RESPONSE TO REVIEW COMMENTS RECEIVED FROM

ANACONDA MINERALS COMPANY:

SILVER BOW CREEK PHASE I REMEDIAL INVESTIGATION

April, 1989

ATTACHMENT A-3

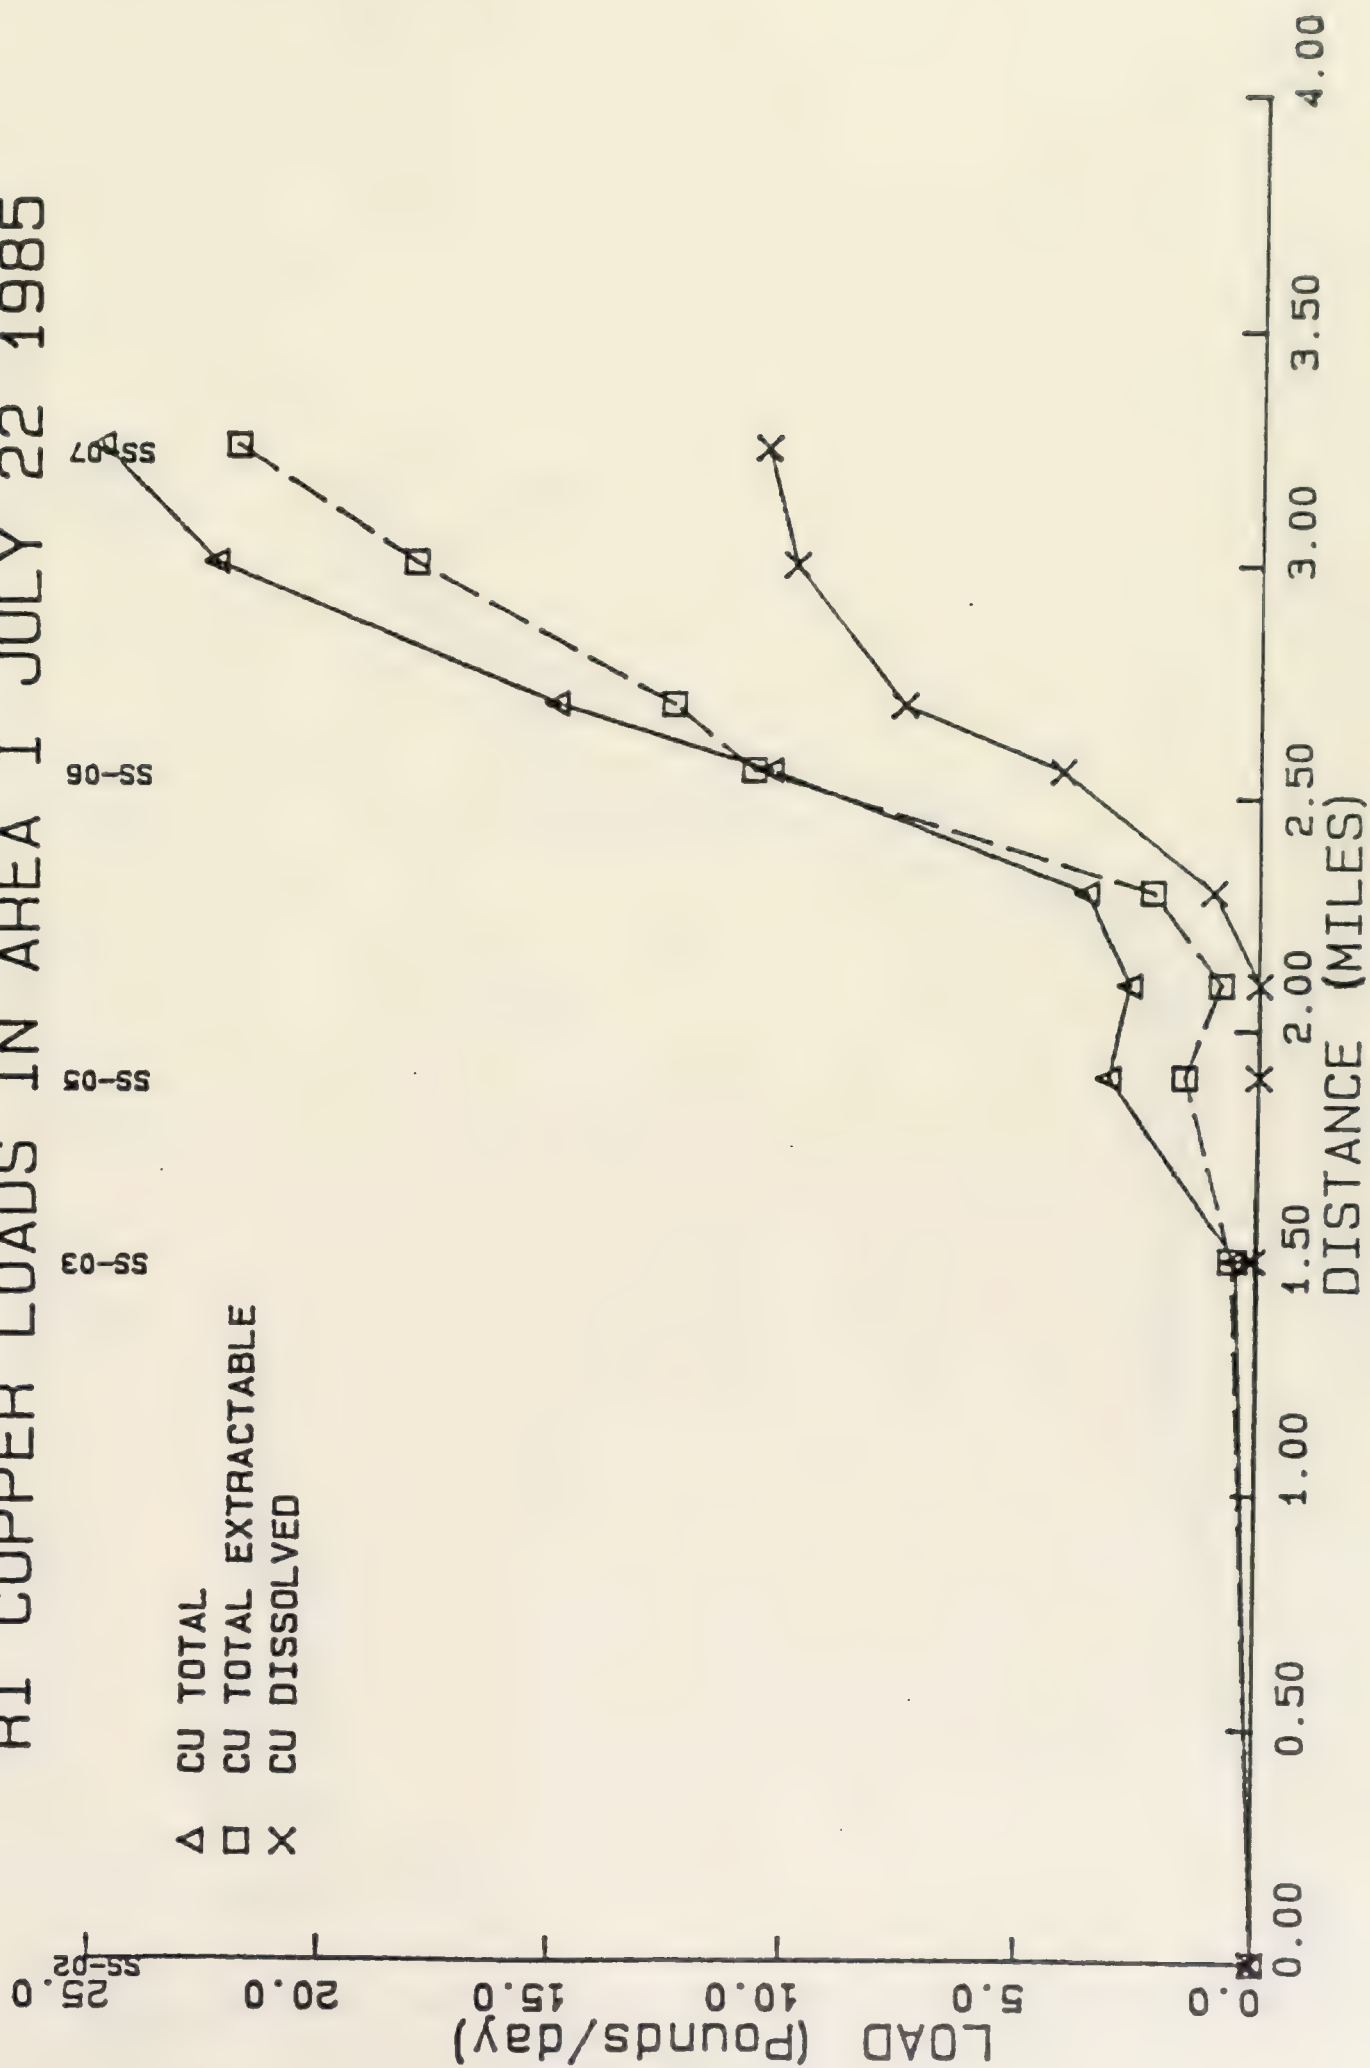
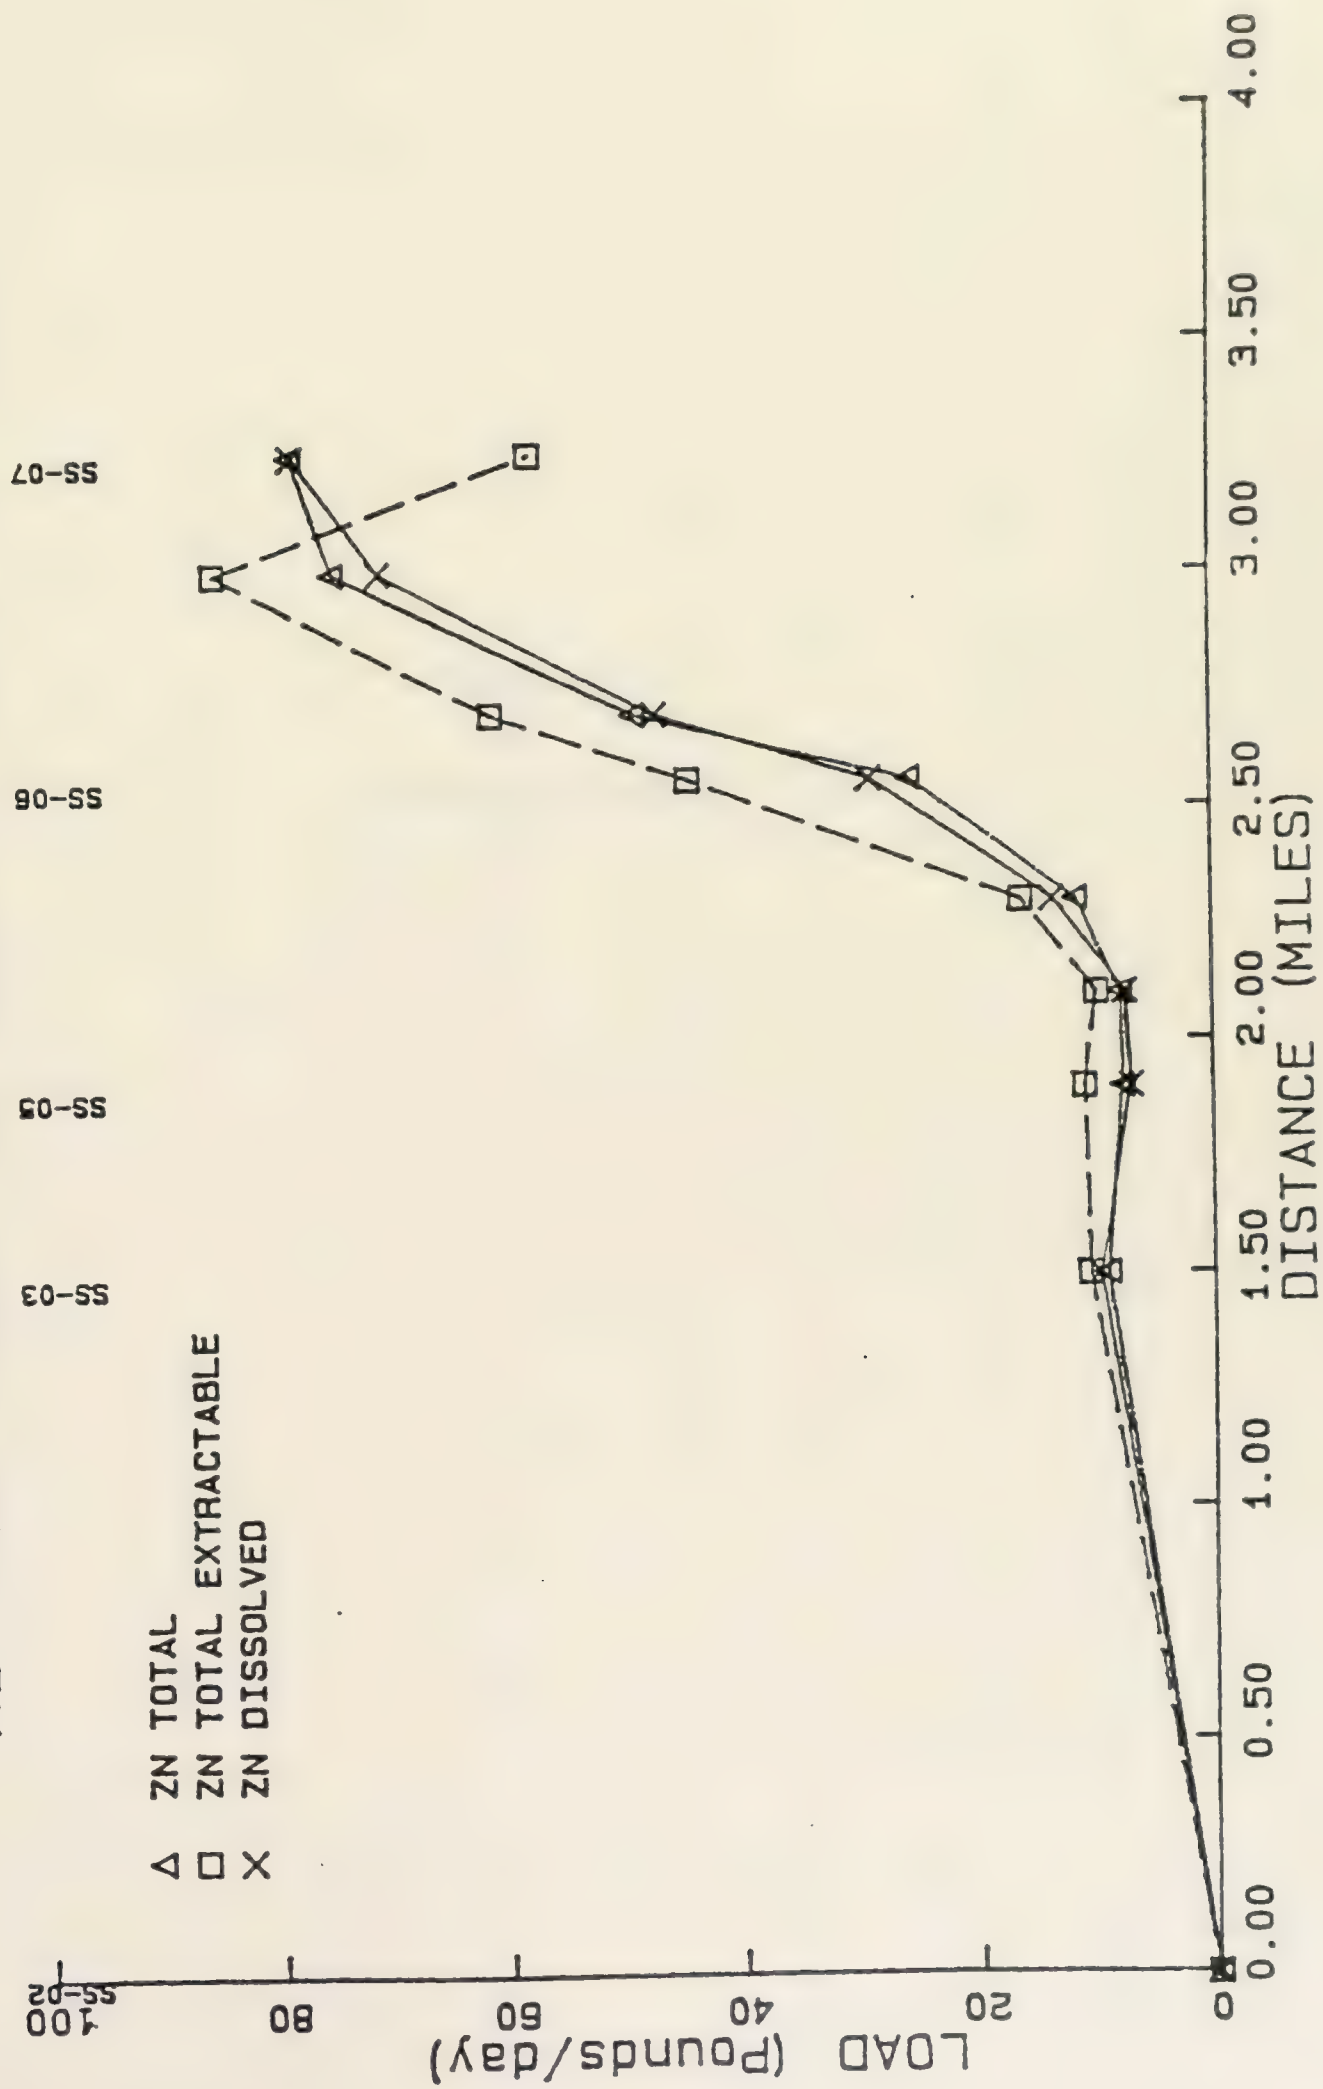
17. Page 3-56, Figure 3-4: It is not clear how Figure 3-4 was generated. It appears to have been derived from the average loading data summarized in Table 3-27. As has already been explained, generalizations based on average values can be misleading. Further discussion is needed in the text to explain how the conclusions in Table 3-4 were drawn and to describe the variability of the data used in the analysis. With this information, the limitations in the conclusion discussed in Figure 3-4 can be clearly identified. Representative stream profiles (see Figure 1) of metals concentrations and loadings showing spatial trends in water quality conditions and illustrating transport mechanisms should be included in the report to help justify the conclusions drawn in Figure 3-4.

In several instances the transport mechanisms presented in Figure 3-4 are not justified based on the data presented (see Table 3-27). For example, Figure 3-4 indicates that under low-flow conditions, sedimentation of solid phase copper occurs in the section of river between Stations SS-07 and SS-08. However, the data summarized in Table 3-27 show that both total suspended solids and solid phase copper loadings increase in this reach which suggests that sedimentation is not occurring in this reach.

Under low-flow conditions, Figure 3-4 also indicates that zinc sedimentation occurs in the reach between Stations SS-04 and SS-07. However, examination of individual data sets from 26 December, 28 January, 11 February, 22 July, and 28 August showed that zinc concentrations did not exhibit a consistent pattern under low-flow conditions. A mass balance on solid phase zinc loading across upper Silver Bow Creek shows that solid phase zinc loading increased rather than decreased between Stations SS-06 and SS-08 on two of the three winter baseflow sampling events. In addition, very little zinc was transported in upper Silver Bow Creek (less than 20 percent) in the solid phase under winter baseflow conditions. Under summer baseflow conditions, zinc was transported entirely in the dissolved phase in upper Silver Bow Creek. Therefore, sedimentation of zinc does not appear to be an important factor in controlling the transport of zinc through upper Silver Bow Creek.

Response: Attachment A-3 to this response document presents figures exhibiting total copper and zinc loads between stations SS-02 and SS-07 on July 22, 1985. Dissolved copper loads increased significantly between Stations SS-05 and SS-07. Dissolved copper inputs to the stream represent degraded groundwater discharge to the stream over this reach, which is the same summary conclusion depicted in Figure 3-4 of the Phase I RI report.

Dissolved zinc loads also increased significantly over the stream reach between Stations SS-02 and SS-07. The near-continuous increase in dissolved zinc load begins higher in the reach than does the gain in dissolved copper loads, which is indicative of the degraded groundwater inputs along the Metro Storm Drain. As with copper loads, however, zinc loads increase appreciably between Stations SS-05 and SS-07. Again, this is the same summary conclusion demonstrated on Figure 3-4 of the Phase I RI report.

It is also apparent from evaluation of the figures in Attachment A-3 of this response document that zinc reacts by means of adsorption and/or precipitation more quickly than does copper. This is likewise in accordance with the summary conclusions indicated on Figure 3-4.
